**Appendix 21: Government Comments**

**Sustainable Forest Management Plan**

## Fort St John Pilot Project

### Collation of technical input received for the draft SFMP #2 and Participant Responses

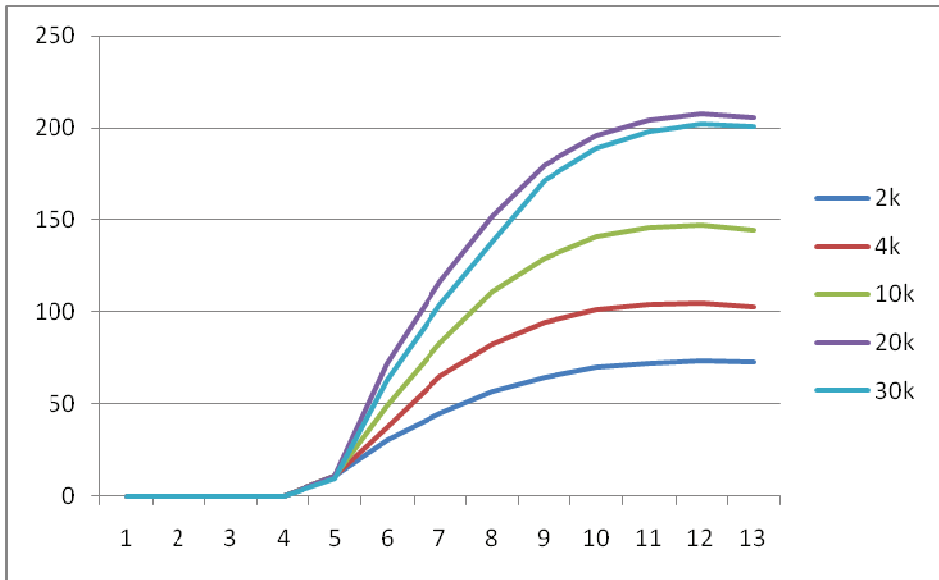
*The table below summarizes a series of MGM 2009 simulations for aspen regeneration in British Columbia. Site index 16, assessment at year 10, average stand height 2.5 m, minimum merchantable diameter of 12.5 cm, Operational Adjustment Factor (OAF) of 20%, and 20% decay and breakage were the assumptions used for these simulations.*

*A stocking level of 4,000 st/ha total stems in these simulations would not reach a minimum merchantable volume of 140 m<sup>3</sup>/ha. With 10,000 st/ha, this would be achieved at 90 years, and at 20,000 stem/ha before year 70.*

*The Code Pilot SFM should be providing regeneration assessments which are consistent with current TSR analysis (e.g. 140 m<sup>3</sup>/ha minimum merchantable stand), and are supported by modelling tools which are currently available. “*

- **The Timber Supply Analysis report for Fort St. John (June 2002) used >120 m<sup>3</sup>/ha as the minimum criteria for aspen stands (Table A-15), and OAF 1 / OAF 2 values of 15% and 5% respectively for assumptions in managed stands.**
